Tilenga Project - Review of Adequacy of Mitigation in Environmental and Social Impact Assessment by Total Exploration and Production B.V. Uganda

December 8, 2019

Bill Powers, P.E.

Figure 1a,²³ exploratory drilling in 2011, & Figure 1b,²⁴ proposed permanent well pads

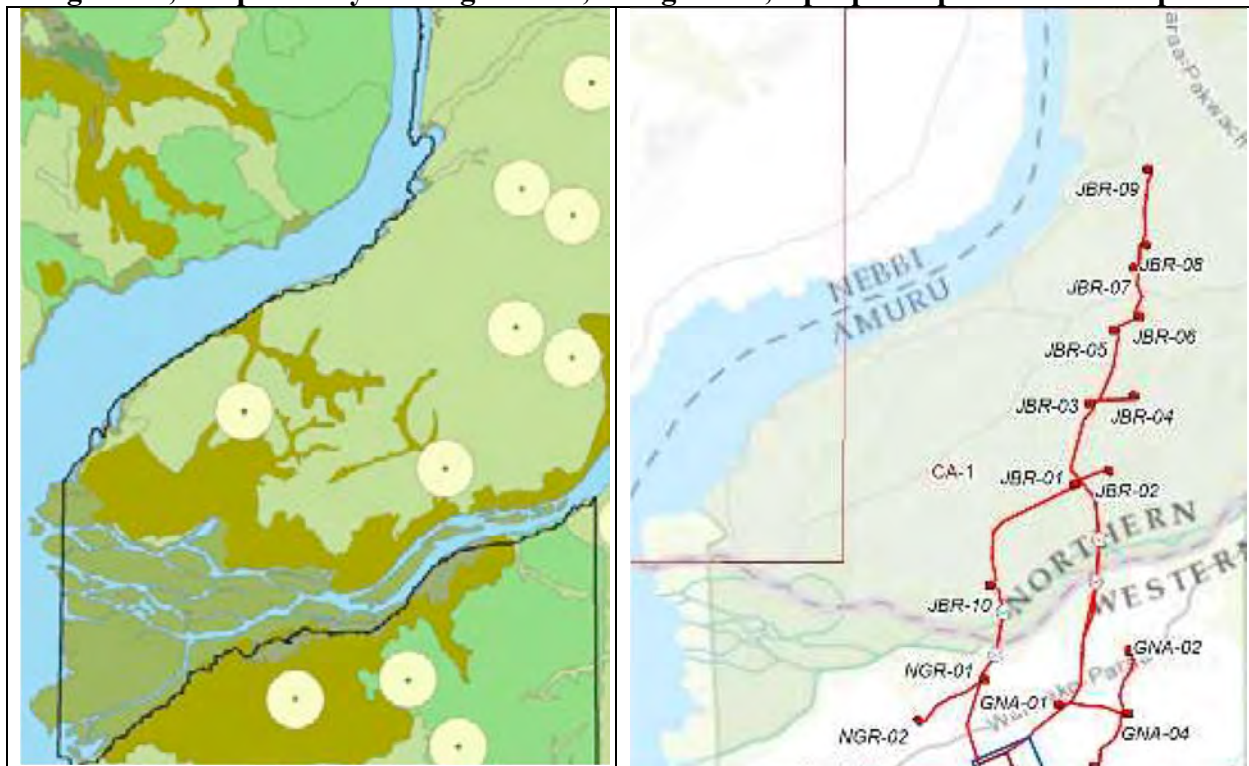
The 2011 study by Wildlife Conservation Society and Uganda Wildlife Authority asserts that the exploratory well pads, with only 2 to 3 km of separation, were too close together to avoid major negative impacts on wildlife in the Park.²¹

The close proximity of well pads in the exploratory drilling program in the will be replicated by TEP Uganda in the operational phase. As a result, the same impacts on wildlife documented in the 2011 study by Wildlife Conservation Society and Uganda Wildlife Authority are likely to recur in the operational phase. The locations of the exploratory well pads and the proposed permanent well pads are shown in Figures 1a and 1b.

The close spacing of the proposed production well pads in the Murchison Falls NP will: 1) have a negative impact on elephant migration within the Park, 2) not maintain the status-quo of the ecosystem, and 3) not be in conformance with the SEA.

Figure 3. Alternative ERD well pad locations (two black dots) to access all drilling targets within Murchison Falls NP with only one drilling pad inside the park⁵¹

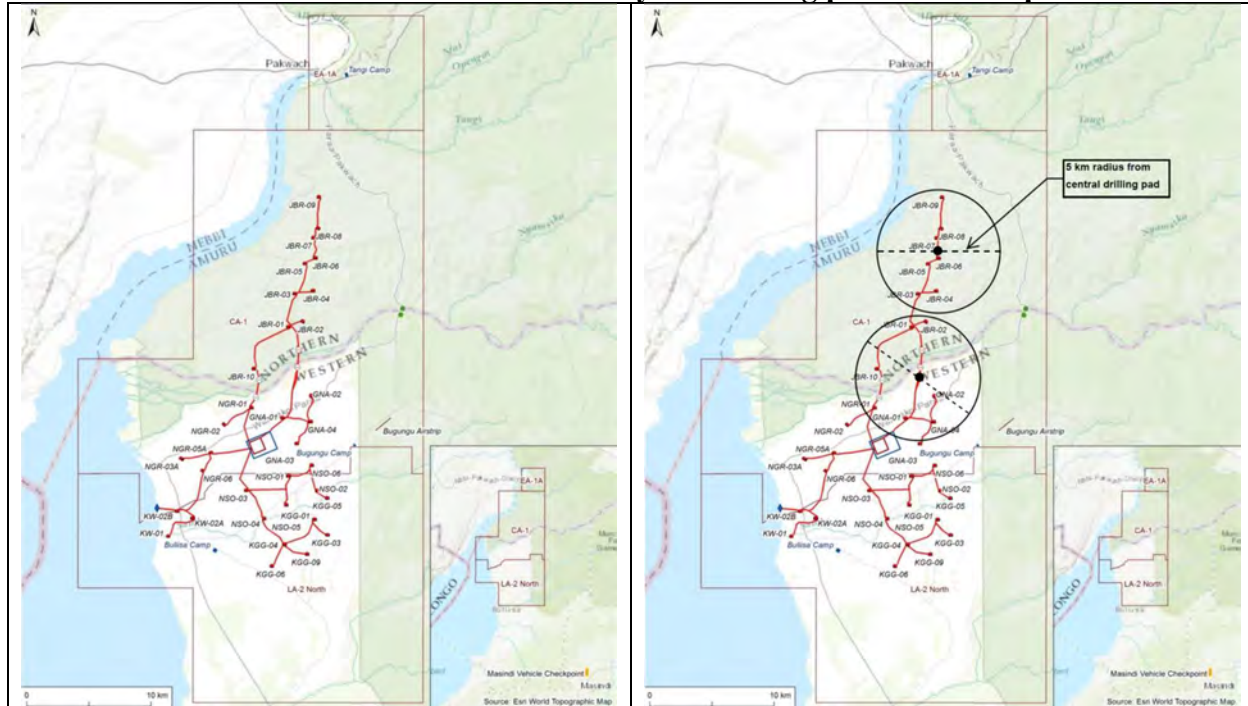
All target oil reservoirs in the Murchison Falls NP can be reached by locating one ERD well pad in the Murchison Falls NP near currently proposed well pad JBR-06, and a second well pad outside the Murchison Falls NP boundary, about 2 km northwest of proposed well pad GNA-02 on the south side of the Victoria Nile. The TEP Uganda drilling plan described in the ESIA is the minimum cost, maximum surface impact approach, not the “*best industry practice*” approach that TEP Uganda states it will follow. The approximate locations of the two alternative well pad sites proposed by E-Tech, consolidating 13 proposed well pads into two ERD well pads, are shown in Figure 3.

Note: black dots and circles added by B. Powers represent potential ERD drill pad locations to access oil deposits within Murchison Falls NP. Due to the shallow depths of the oil deposits, on average 500 m. or less, the maximum horizontal reach of ERD wells would be about 5,000 meters (5 km) based on the current state of ERD drilling technology.

The number of well pads needs to be further optimized. TEP Uganda proposes to drill 98 wells from seven well pads, JBR-03 to JBR-09, that would be difficult to reach with ERD wells from outside the Murchison Falls NP. The reservoirs these wells are intended to access should be developed from a single well pad inside the Murchison Falls NP, as shown in Figure 4. TEP Uganda should further optimize/ reduce the number of wells to be drilled to minimize the potential for wellbore collisions. The layout of the single pad in the Murchison Falls NP should be based on the layout of concentrated well clusters on offshore oil platforms, that have as many as 80 wells.⁵⁶
